Updated Cylinder Head for CVO

As of March 18, 2008 all 110 cubic inch CVO motorcycles will receive changes to the valve guides. The following information applies to all current production 1800 cc engines, 27800-08A & 27801-08A Screamin' Eagle 110 P&A kits (shipped after 5/26), and their service part level cylinder heads.

Figure 2

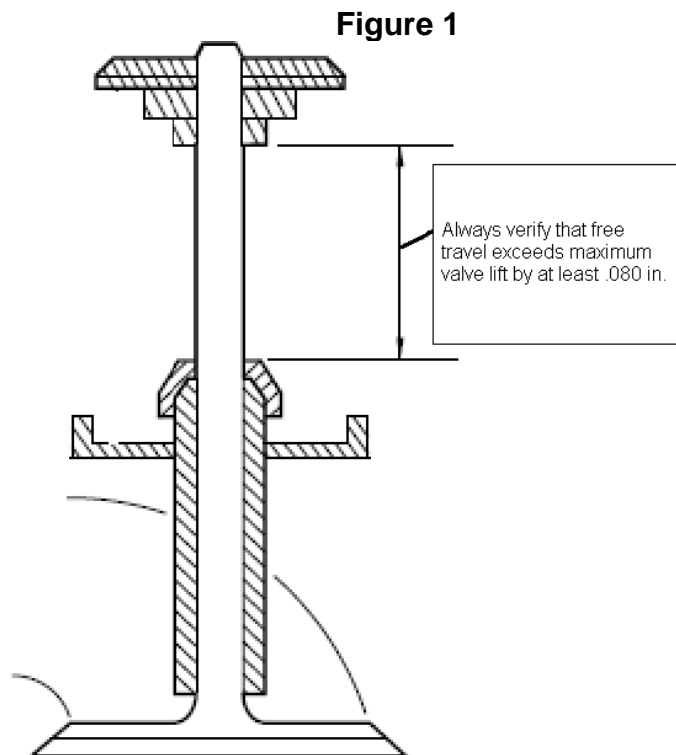
2. The intake guide is slightly shorter than the exhaust and can be identified by a small groove on the port end of guide. (see Figure 2)
3. You can also identify the vintage on an assembled motor by looking at the guide through the exhaust port. (see Figures 5 and 6)

Figure 3

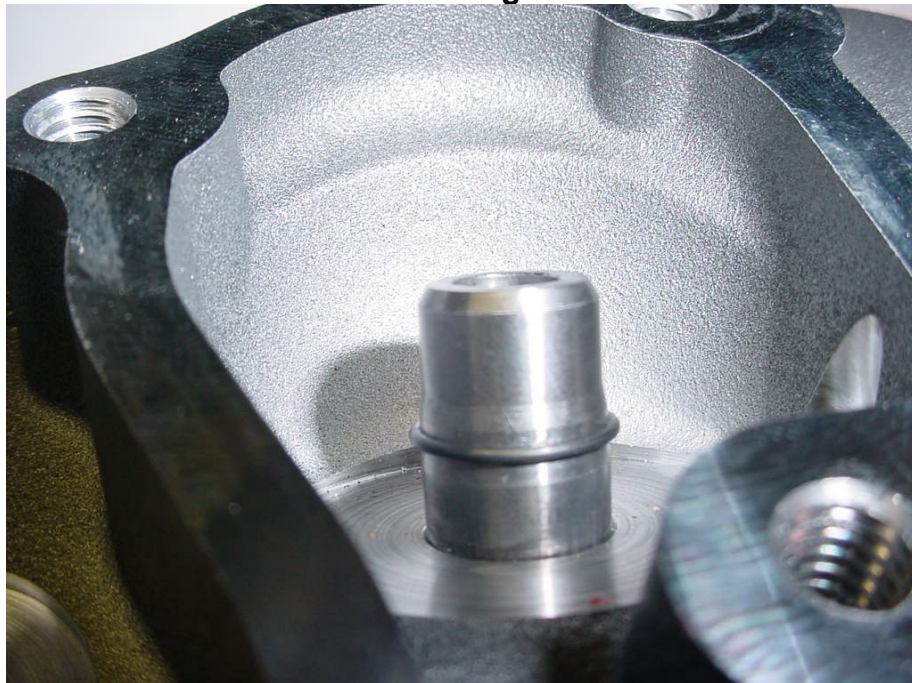
4. Retention clips have been added to both, intake and exhaust valve guides. (see Figure 3)
5. A small gap of approximately **.070"** between the valve spring collar and the guide retainer clip should be considered normal. (see Figure 4)
